Access Compliance Report

Public Rights-of-Way

(Curb Ramps)

Intersection ID: 14731	Main Street: NORLAND_RD	Cross Street: WOODLAND_DR	Location:	N
ADA ID: 735FFE599125	Ramp Type: PerpDiag	Initial Pass/Fail: Fail	Overall Compliance: No	Severity Score: 13.75
Codes/Mitigation Info/Possible Solution		Field Measurements/Component Compliance

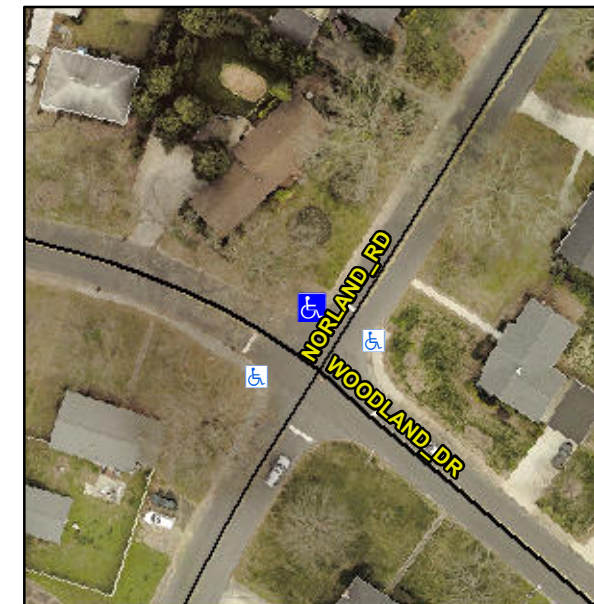
Not Found, R304.2.2, R304.5.3

Compliance	Description	Data	Compliance	Description	Data
N/A	Ramp Length (in)	50.5	No	Ramp Slope (%)	9.9
Yes	Ramp Width (in)	48.0	No	Ramp XSlope (%)	5.0
N/A	Flare Type LT	N/A	N/A	Flare Type RT	N/A
N/A	Flare Slope LT (%)	N/A	N/A	Flare Slope RT (%)	N/A
N/A	Flare Traversable LT?	N/A	N/A	Flare Traversable RT?	N/A
N/A	Landing Length (in)	N/A	N/A	DWS Provided?	N/A
N/A	Landing Width (in)	N/A	N/A	DWS Contrast?	N/A
N/A	Landing Slope (%)	N/A	N/A	DWS Length (in)	N/A
N/A	Landing X Slope (%)	N/A	N/A	DWS Full Width?	N/A
N/A	Landing Curb? (Y/N)	N/A	N/A	DWS Offset (in)	N/A
N/A	Shared Landing?	N/A			
N/A	Gutter Ponding?	N/A	N/A	Gutter Slope (%)	N/A
N/A	Gutter Lip Ht (in)	0.5	N/A	Gutter X Slope (%)	N/A
N/A	Painted X Walk1?	No	N/A	Painted X Walk2?	No
	X Walk 1 Direction	To SW		X Walk 2 Direction	To SE
N/A	X Walk 1 Width (in)	N/A	N/A	X Walk 2 Width (in)	N/A
	X Walk 1 Slope (%)	3.0		X Walk 2 Slope (%)	6.9
	X Walk 1 X Slope (%)	5.3		X Walk 2 X Slope (%)	2.6

N/A	Ramp inside XWalk1?	N/A	N/A	Ramp inside XWalk2?	N/A
	Road Slope (%)	5.2	N/A	Clear Space?	N/A
	Road X Slope (%)	6.1	N/A	Clear Space to XWalk (in)	N/A
N/A	Any Obstructions?	N/A	N/A	Storm Grate/Utility Hazard?	N/A
	Obstruction Type			Storm Grate/Utility Type	
		N/A			N/A
			Yes	Surface Condition? (G/P)	Good

Remove & Replace Curb Ramp With Two New Directional Ramps or Equivalent.
